# Memorandum

Subject: January 2008 Agenda  
Agenda Item No. 1

Project: Patterson Crossing Retail Center  
TM #22.-2-48

TO: Town of Kent Planning Board  
From: Neil A. Wilson, AICP  
Date: January 10, 2008  
Re: Patterson Crossing - Site Plan Approval

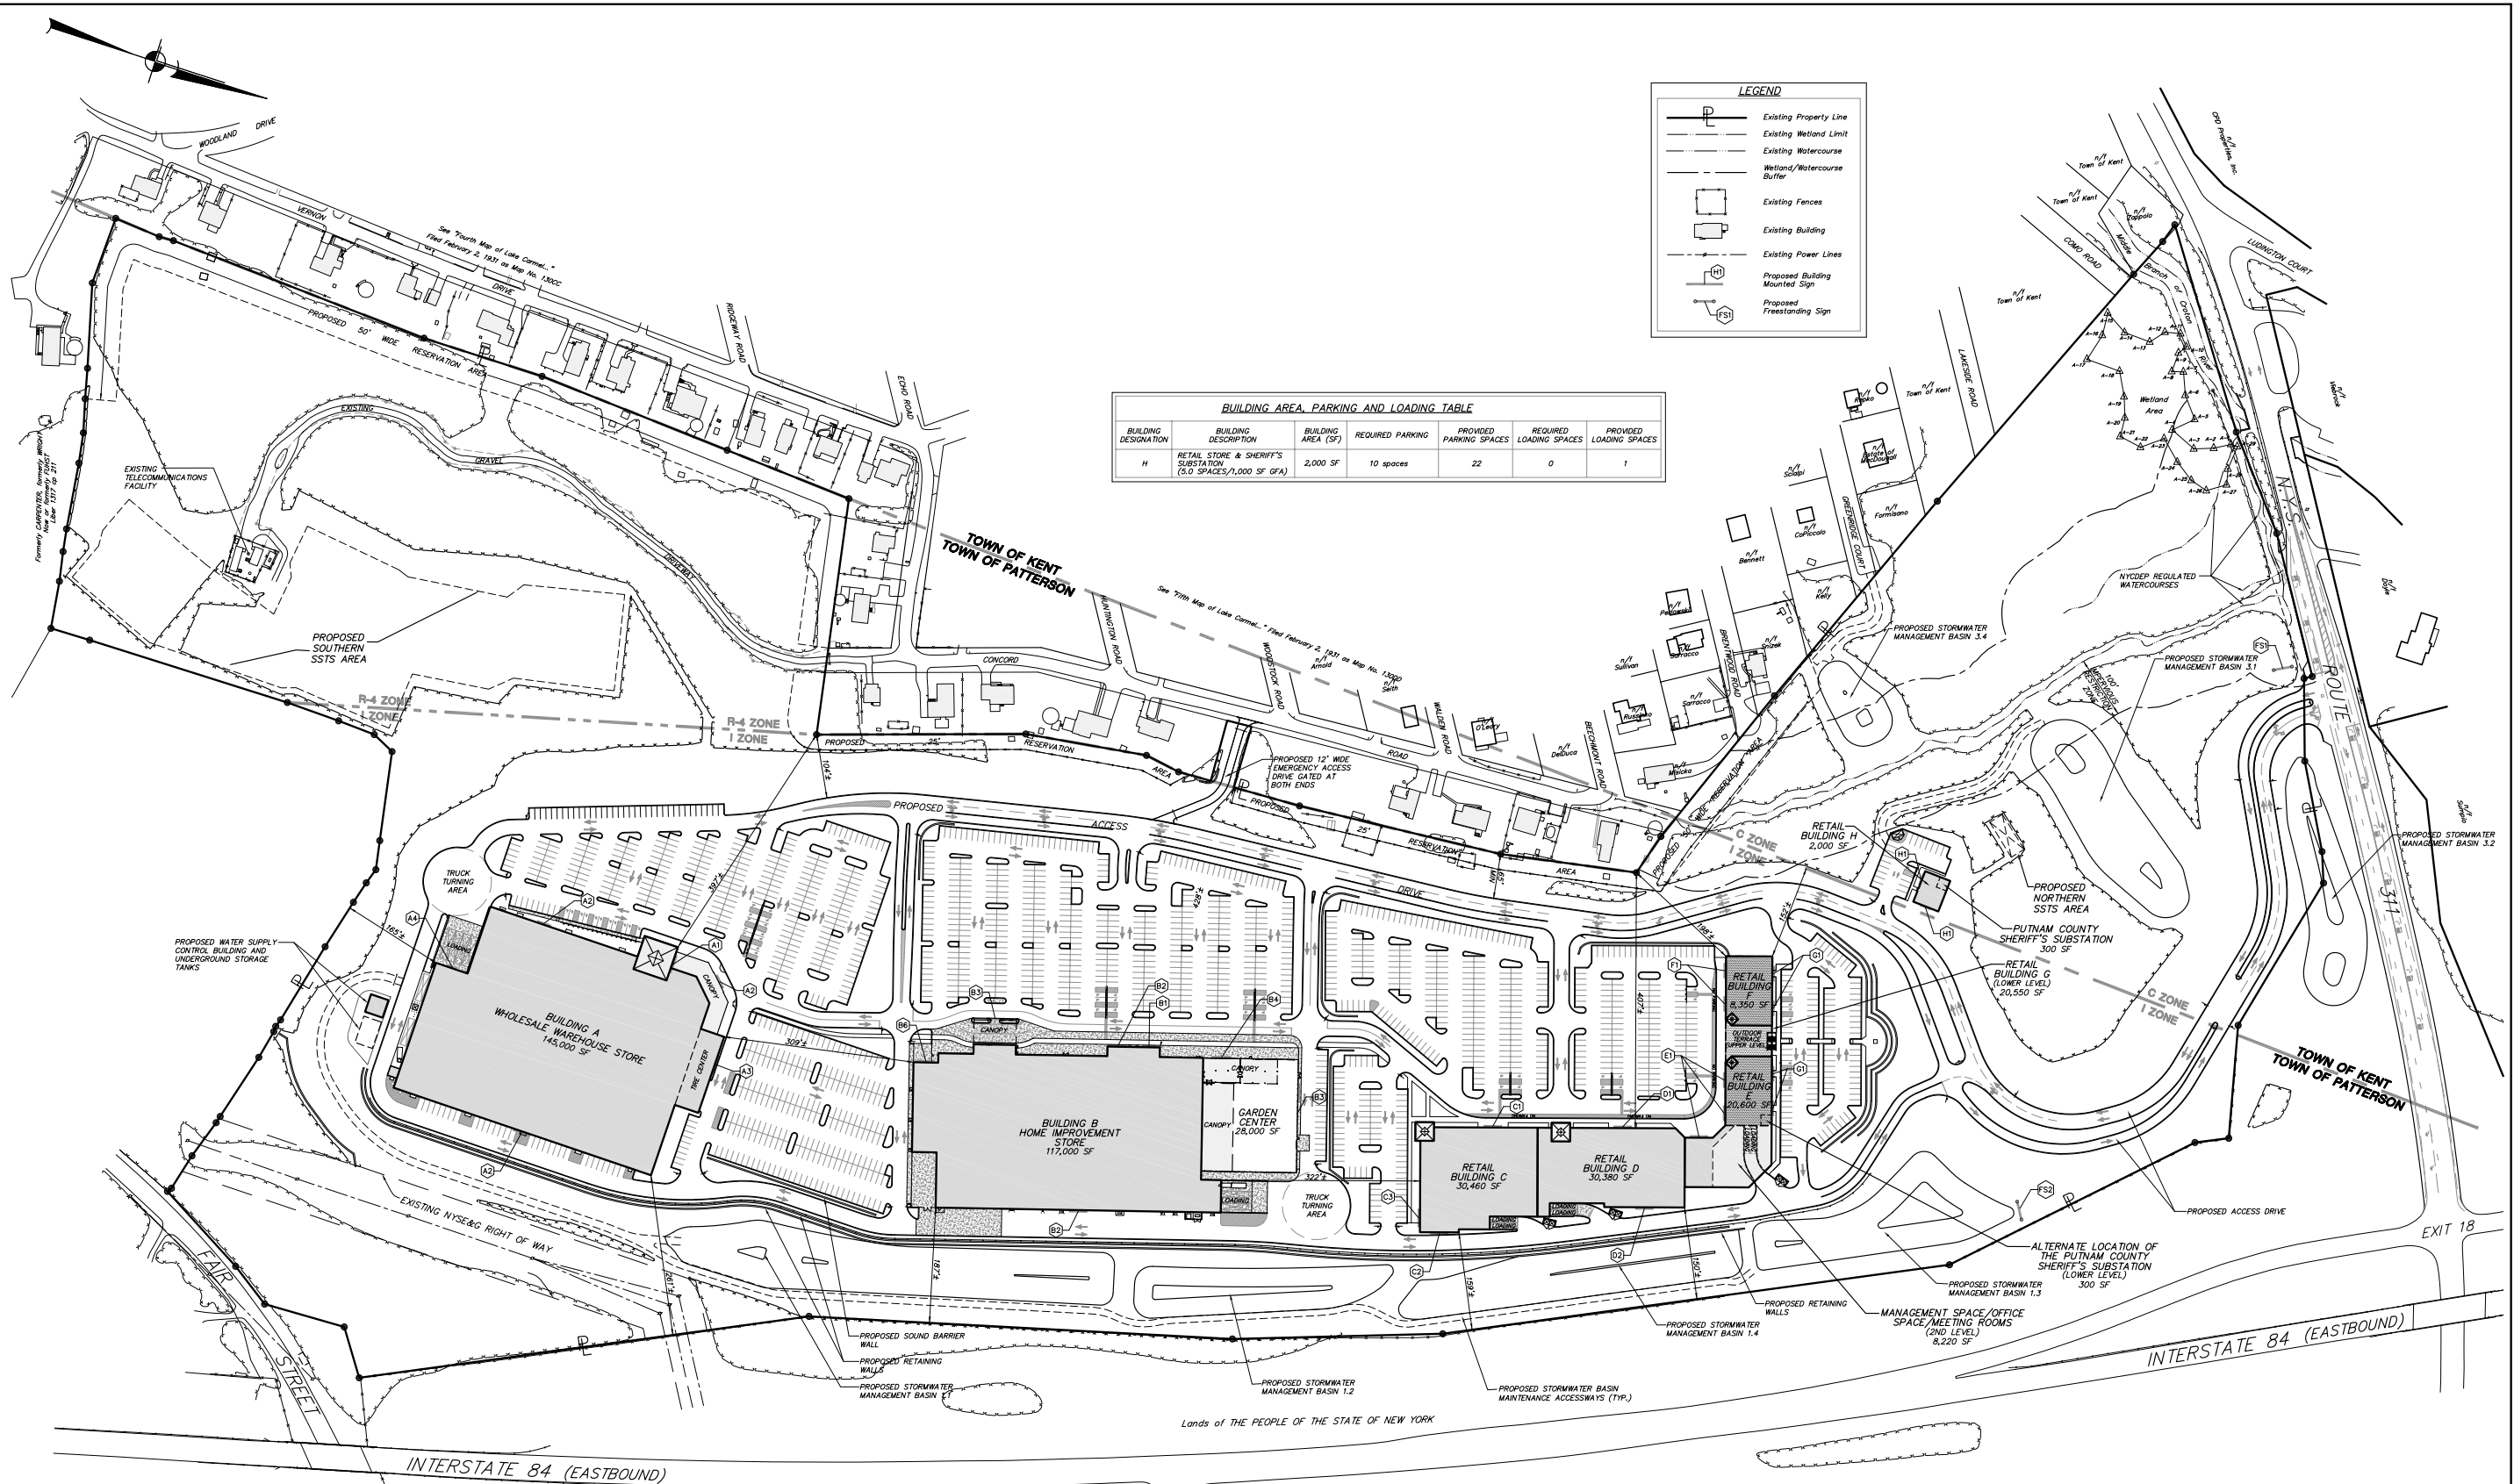
2. Refer to the drawings:
  - a. EX-1:
    - i. The boring logs indicate that refusal occurred at a shallower depth than shown on the drawing for the following borings: 24-22'/45'; 25-37'/45'; 26-21'/40'; 27-27'/35'; 28-6'-6"/20'; 30-5'-6"/20'; and 31-13'/15'.

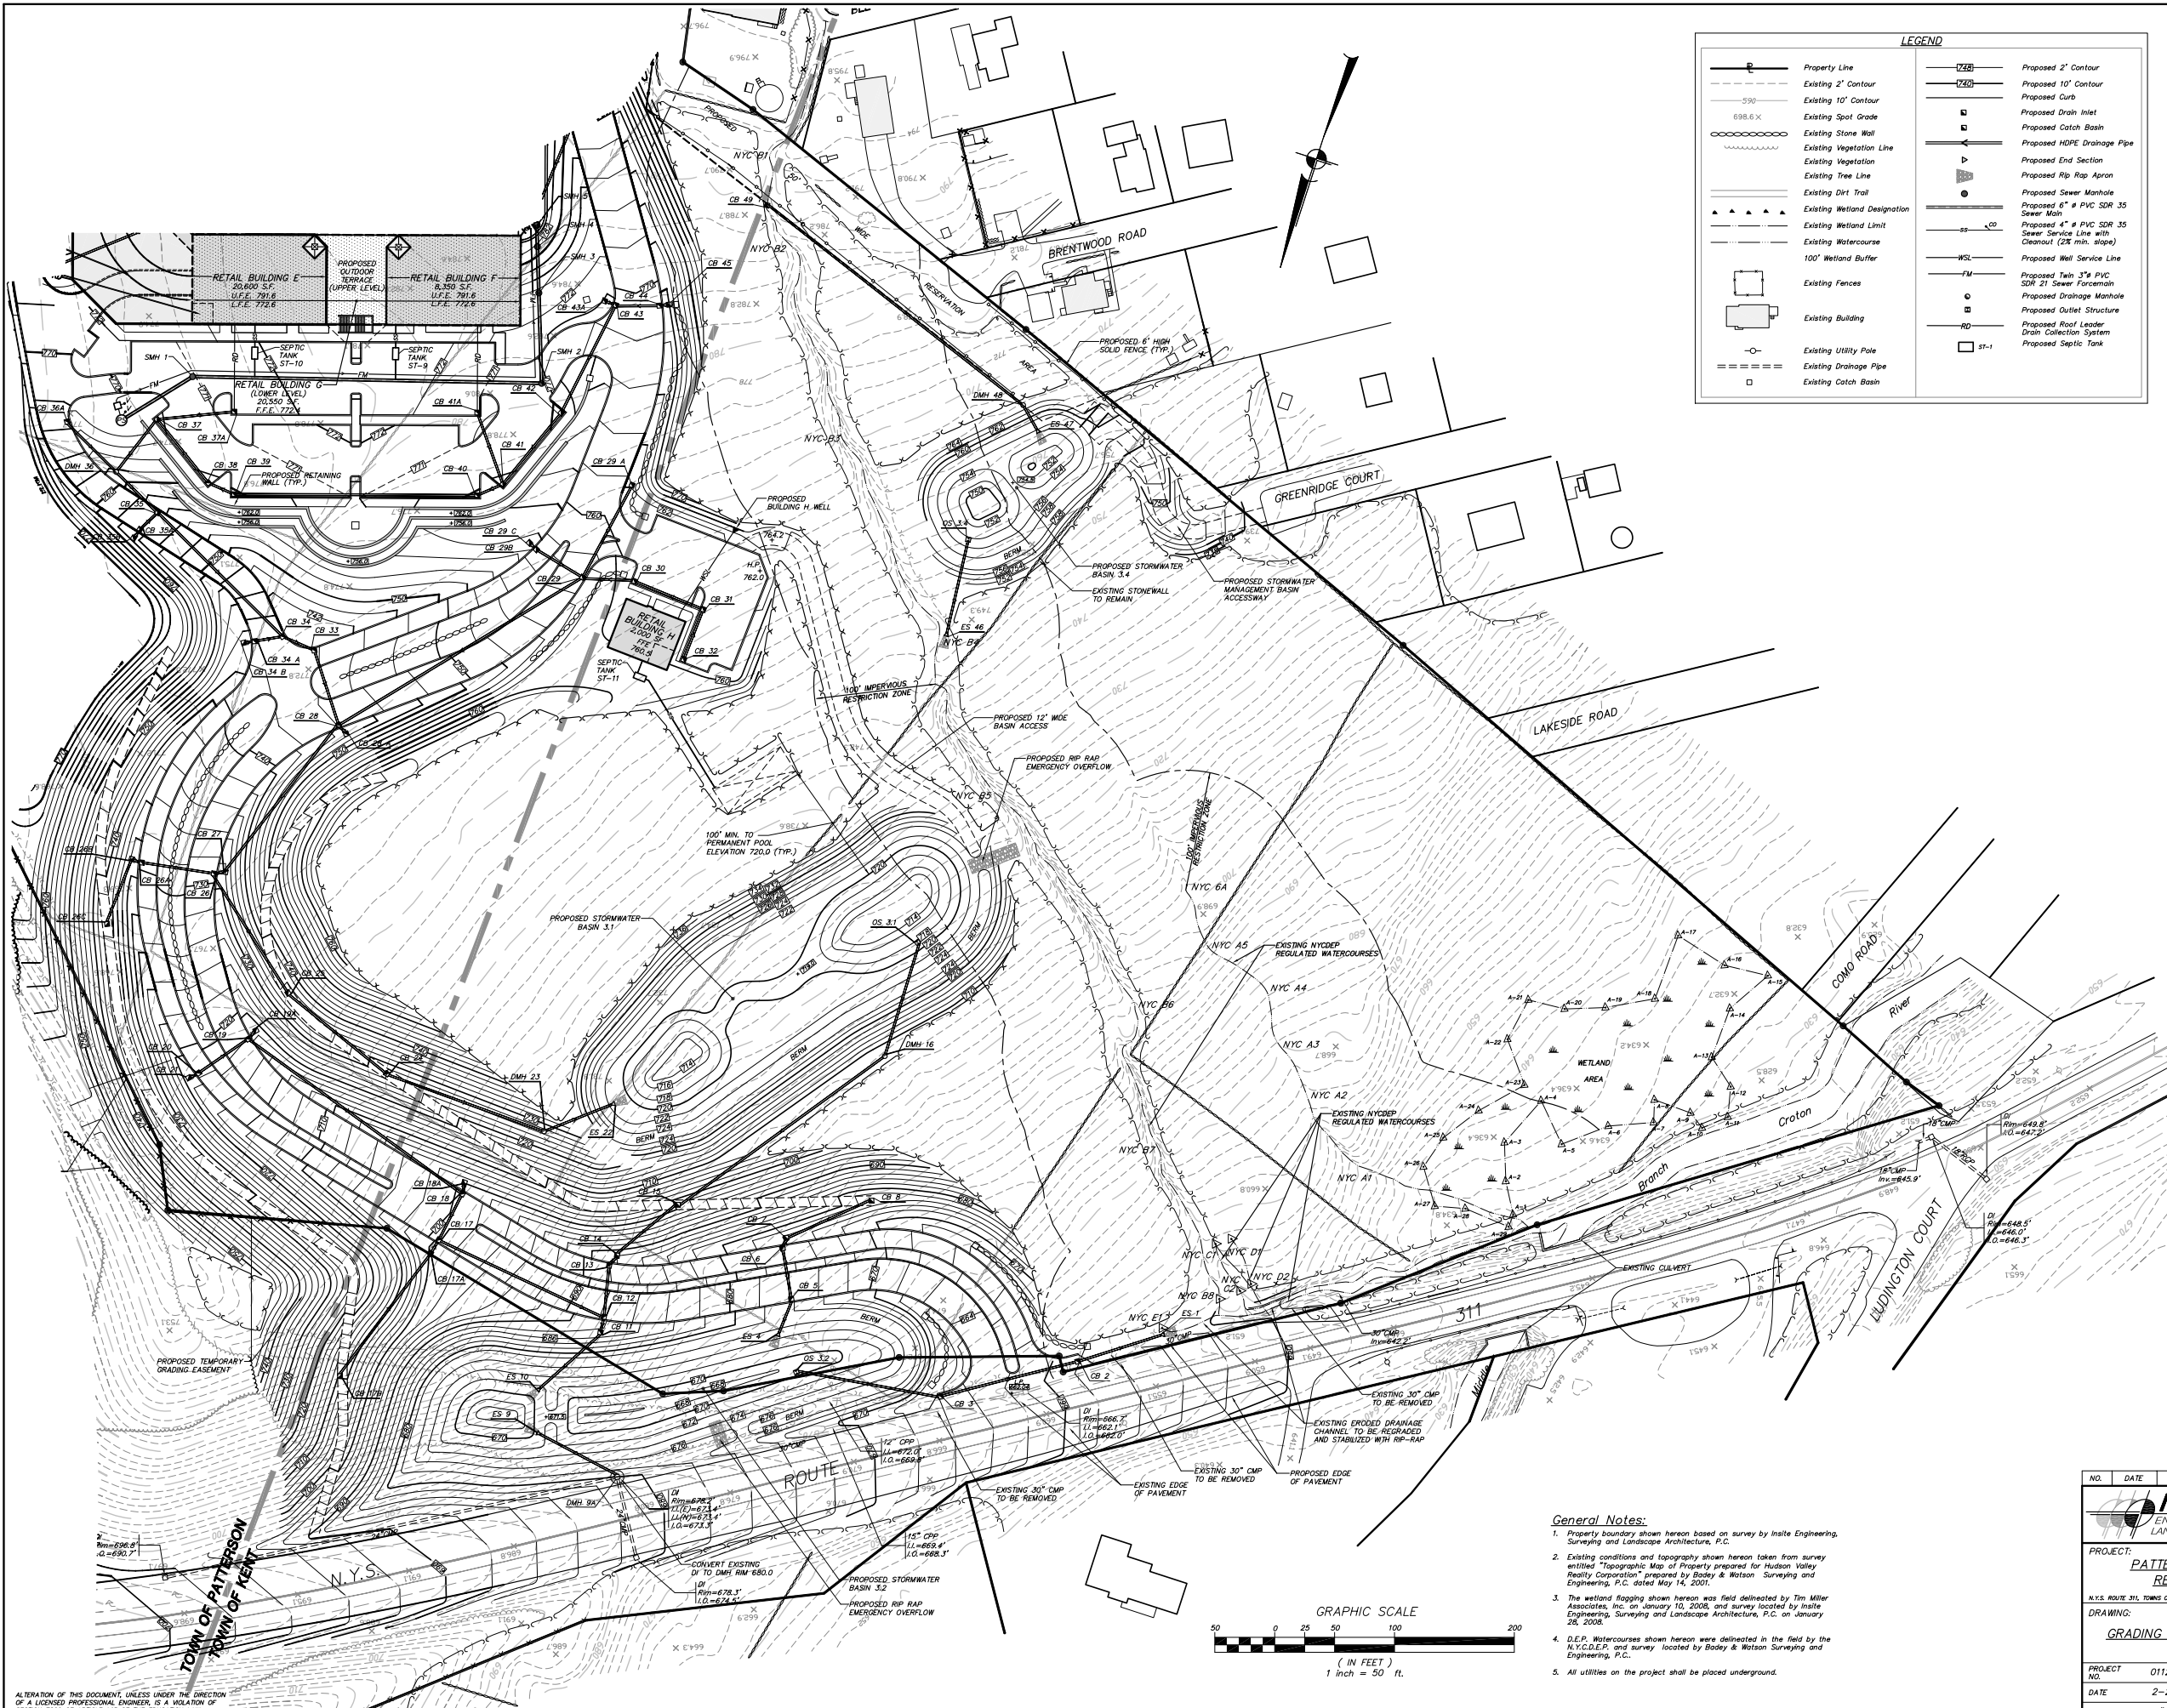
- b. SP-2.1:
    - i. The visual/sound barrier and plantings do not extend for the full length of the property line between the commercial and residential zones.

PROFILE STORMWATER BASIN 3.1 ACCESS  
SCALE: HORIZONTAL 1" = 30'  
VERTICAL 1" = 10'

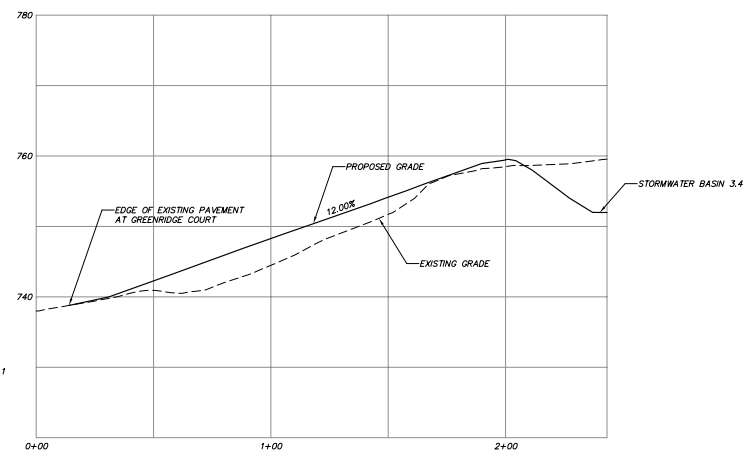
- c. SP-3.1:
    - i. Provide a profile for the access road to stormwater basin 3.4.
    - ii. Provide a profile for the access road to stormwater basin 3.1.
